SECTION 00942 – Change Order Form

No. 1DATE OF ISSUANCE: May 10, 2024EFFECTIVE DATE: May 10, 2024

OWNER: Indian River County
 CONTRACTOR: Close Construction Services
 Project: Kiwanis Hobart Park New Restroom
 OWNER'S Bid No. 2023047

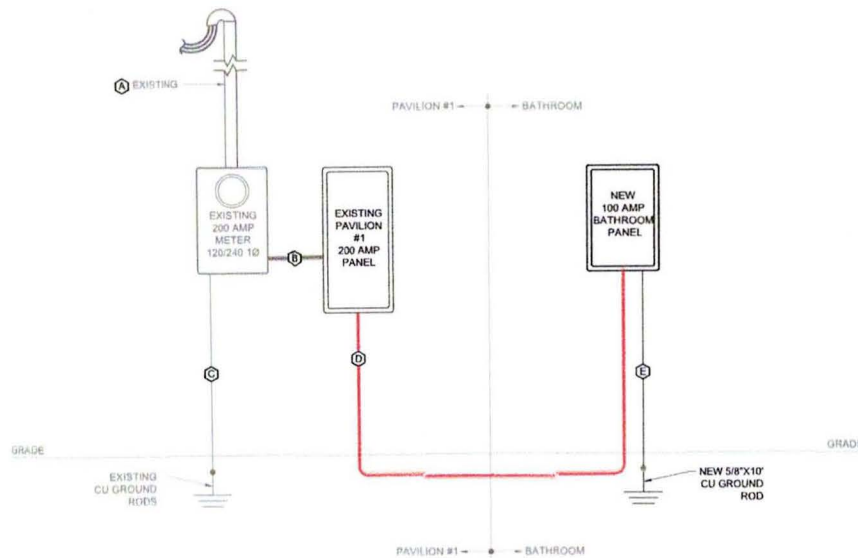
Per the “proposed riser changes” indicated on Page E-1, we are pleased to offer the following proposal to extend the electrical conduit and wire an additional 30’ to an existing panel and pull the power from the existing meter and panel, including necessary saw cutting and patching:

The building inspector has asked that the Page E-1 be amended, signed and sealed so that we may submit it to the building department to update the permit and permitted plans.

Extend Conduit and wire an additioanl 30' to an existing electrical panel.

- INSTALL (1) 100 AMP SUB PANEL AT NEW BATHROOM STRUCTURE.
- FEED NEW BATHROOM PANEL UNDERGROUND FROM EXISTING 200 AMP PANEL AT PAVILION #1.
